STAFF REPORT

BARTHOLOMEW COUNTY PLAN COMMISSION (December 9, 2015 Meeting)

Docket No. / Project Title: MA/C-15-02 (Driftwood Center, Section1)
Staff: Allie Keen
Applicant: Edin-Apple, LLC
Property Size: +/- 30.66 Acres
Current Zoning: CR (Commercial: Regional) & I-1 (Industrial: Light)
Location: North and south sides of Hartman Drive on the west side of US 31, in German Township.

DRIFTWOOD CENTER, SECTION 1 REVISED CONCEPTUAL PLAN

Applebee's Edinburgh Indiana
CONCEPTUAL PLAN

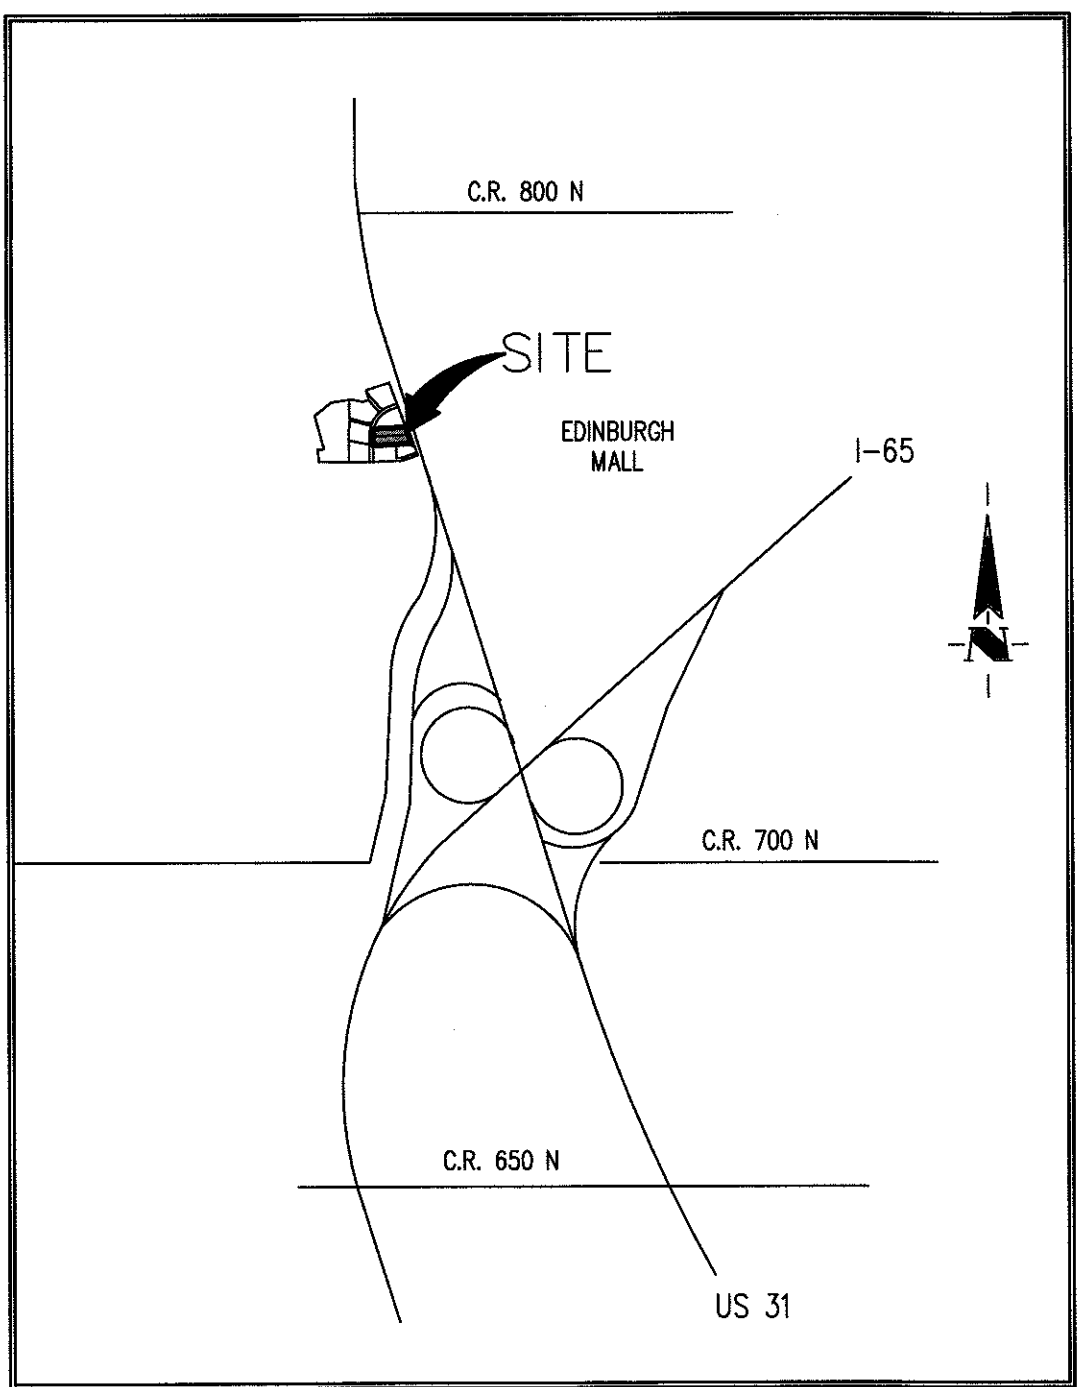
1. In the title block, revise the project name to "Driftwood Center, Section 1 Revised Conceptual Plan" to be consistent with the title of the plat.
2. Label the drainage pattern arrows on the drawing or provide a legend, per Subdivision Control Ordinance Section 8-42(b)(2)(g).
3. Please include a "in only" traffic circulation arrow for Lot 7A to be specific to each lot this provision applies to as well as consistent with the approved Driftwood Center final plat.
4. The platted "No Access" easement in its entirety should be shown on the drawing to be consistent with the final plat. This easement is along the entire US 31 frontage of Lots 5, 6, 7A, 8A, 9, and 11.
5. Rename the "Heflin Park Road" to just "Private Street".
